City of Chelsea Planning Commission

AGENDA

Tuesday, August 15, 2023 at 7:00 PM

**Site Plan Approval
for
City of Chelsea, Michigan**

Client
HURON WATERLOO PATHWAYS INITIATIVE
Project
TIMBERTOWN PARK - PARKING LOT IMPROVEMENTS
Title
PROPOSED DETAILED GRADING PLANS

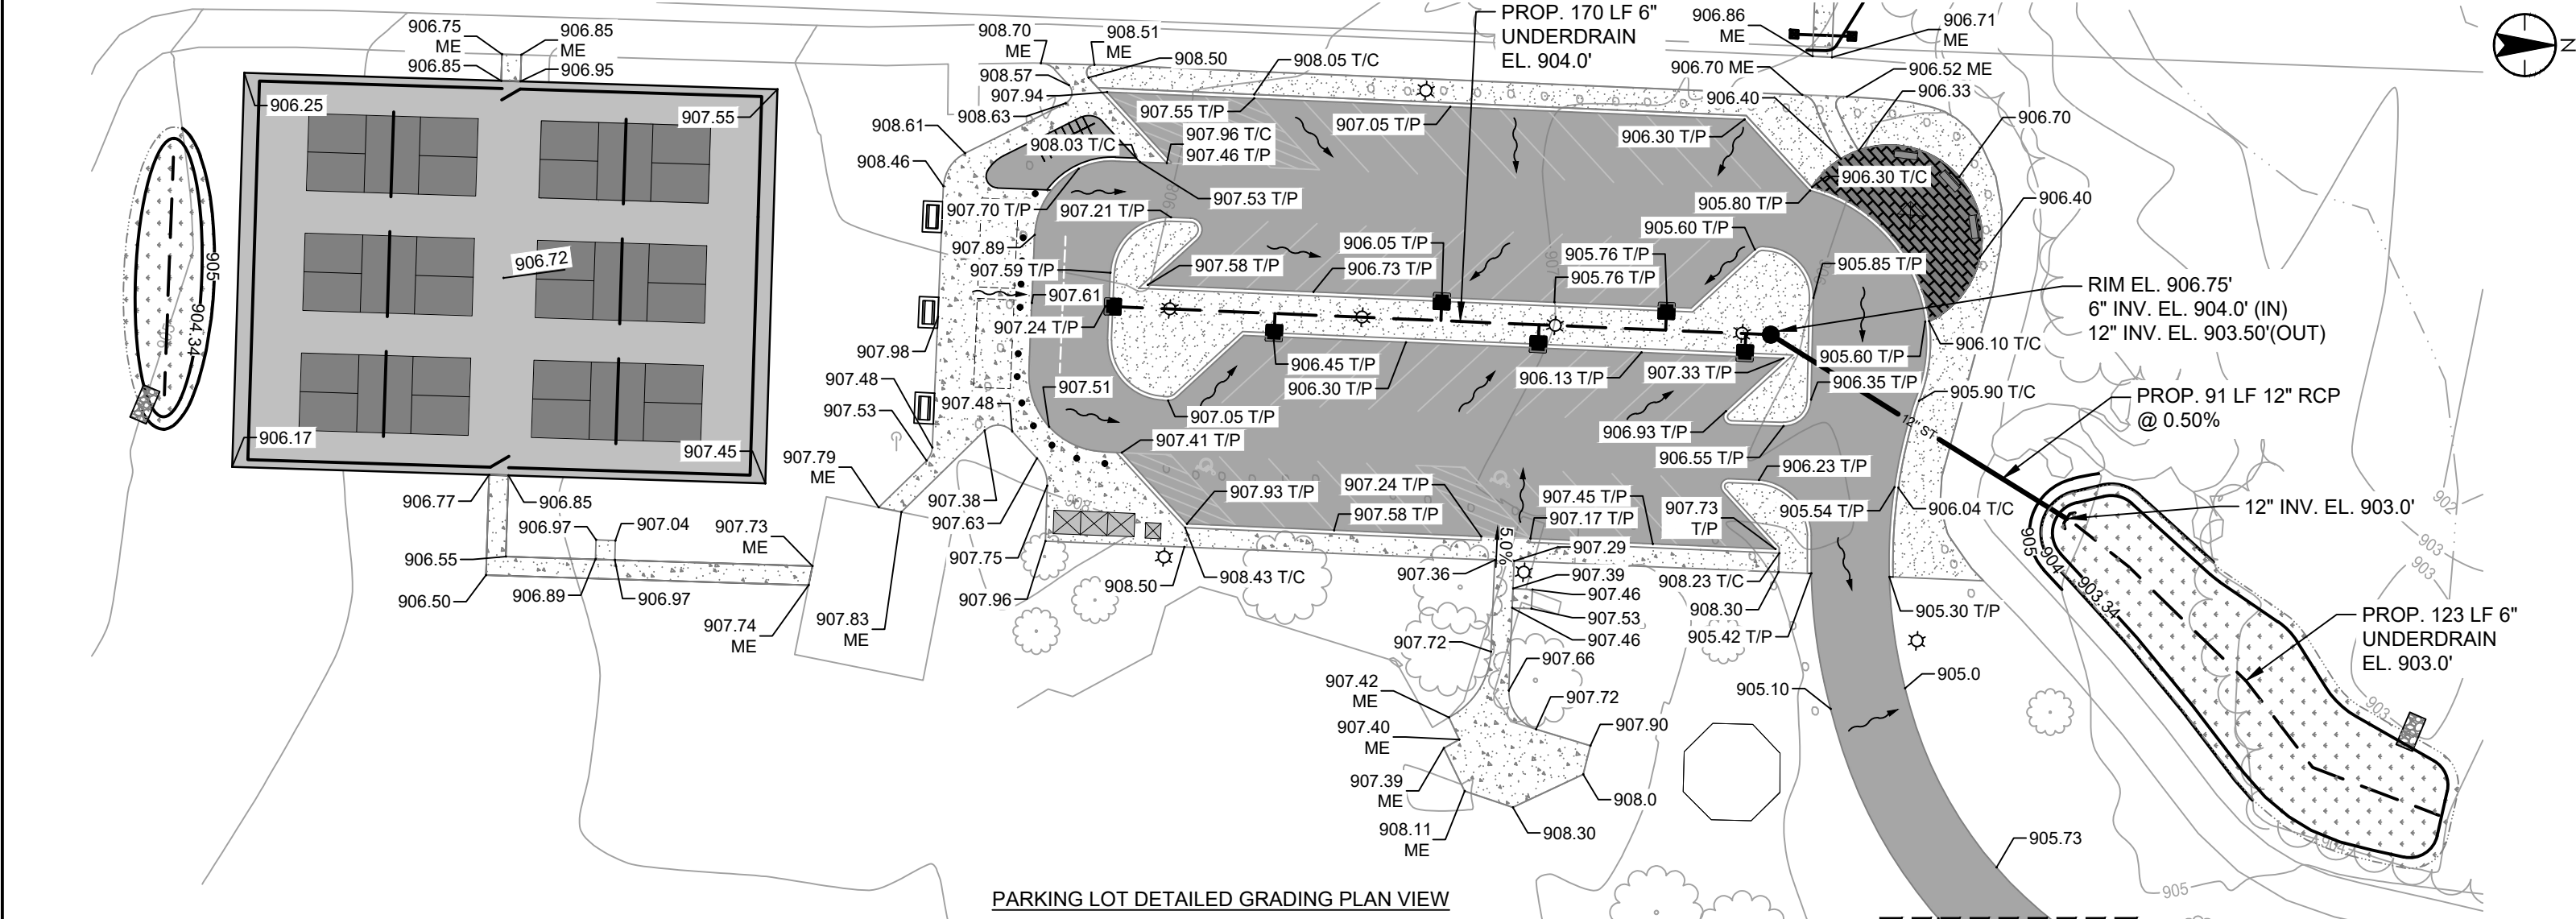
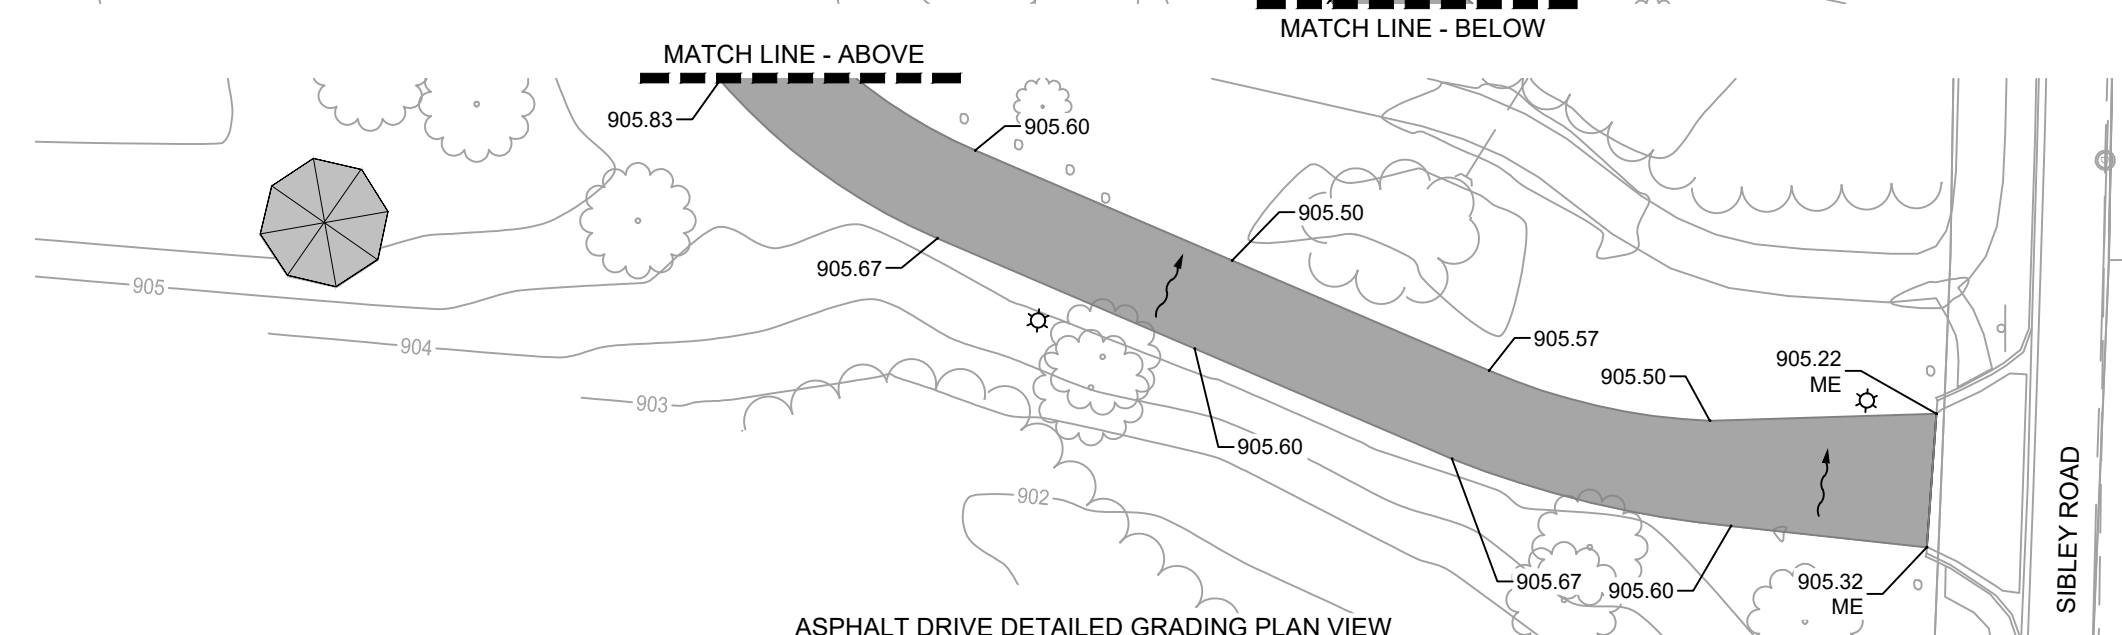
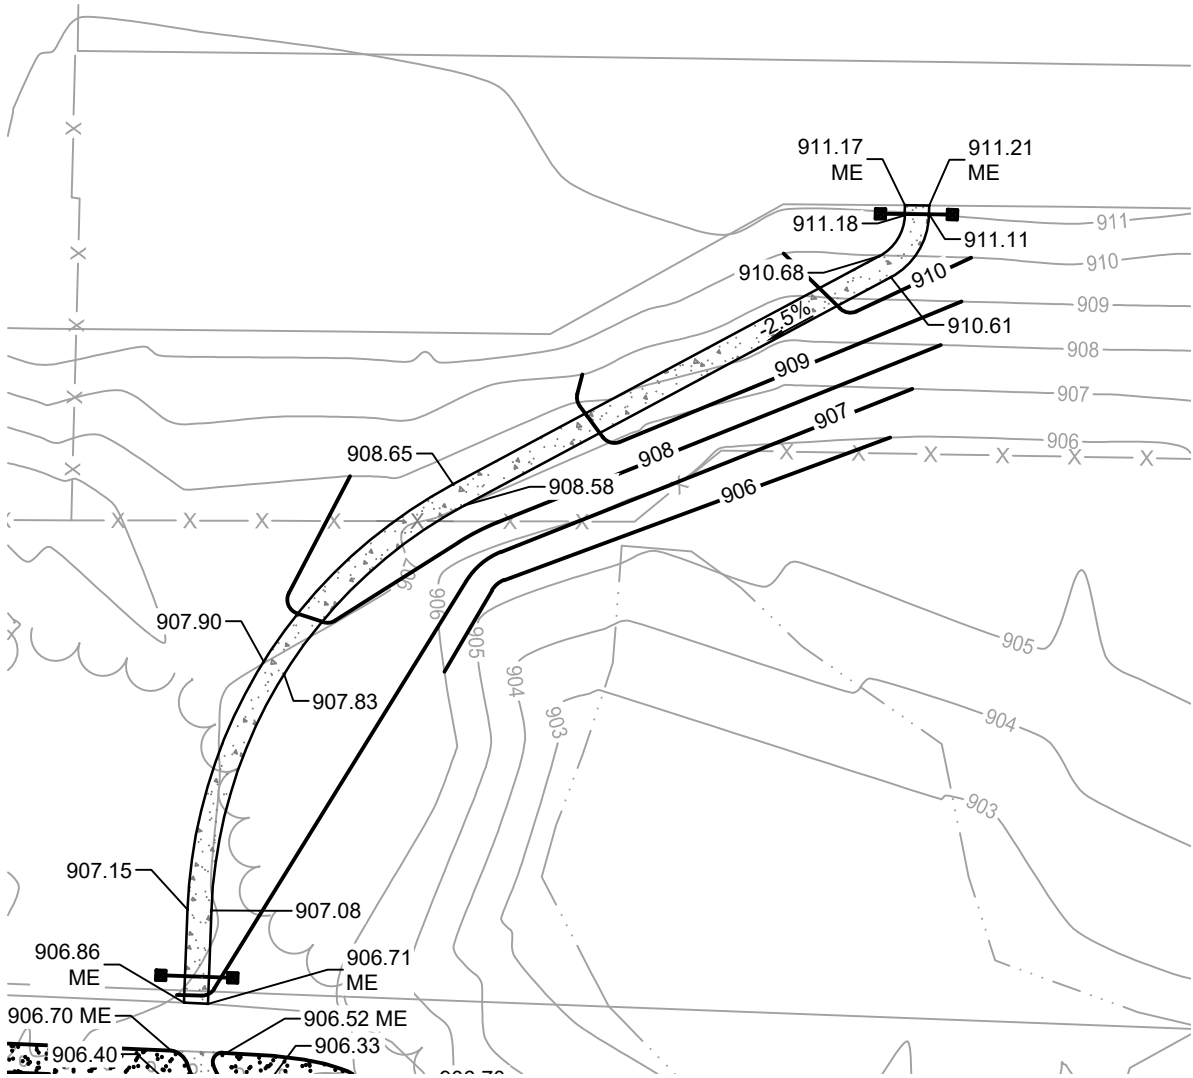
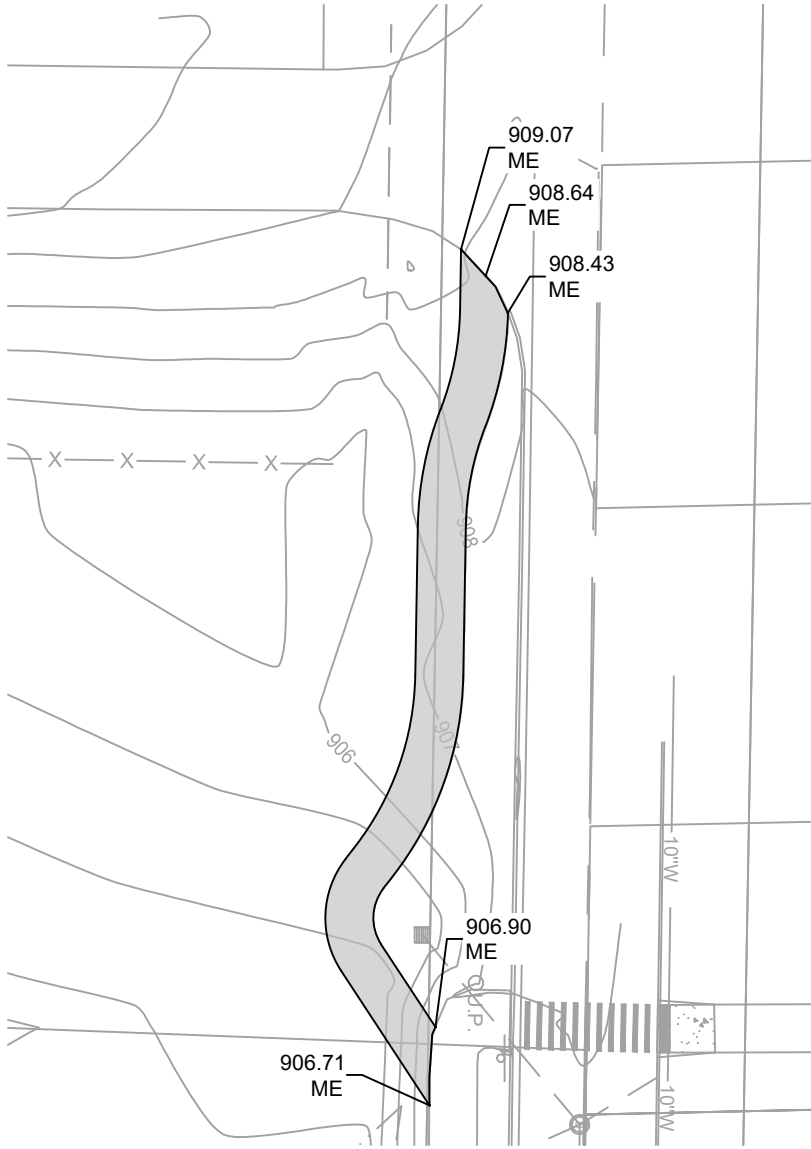
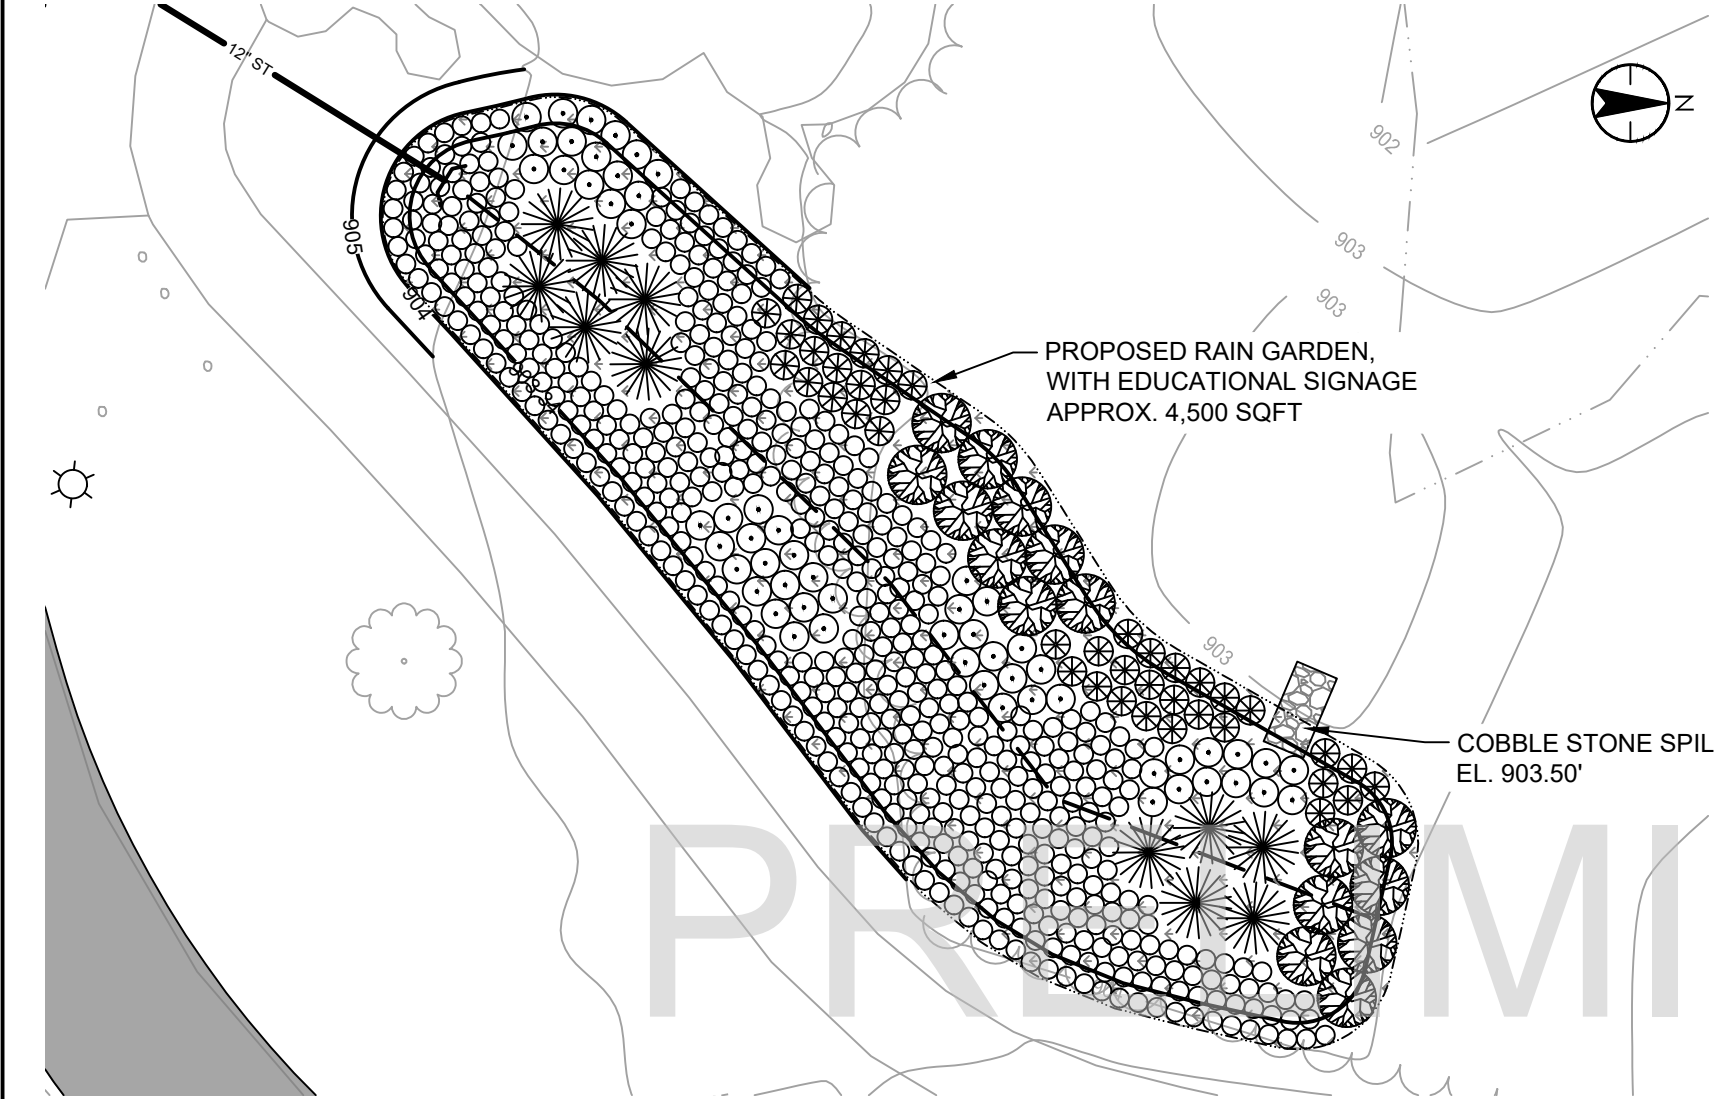
A grading plan is provided on sheets 10 through 12. The grading plan indicates the addition of a proposed cobble spillway to the proposed raingarden on the north of the parking area. Two rain gardens are included as part of the project.

Items to be Addressed: *We defer to the City Engineer to review grading, drainage, and stormwater plans.*
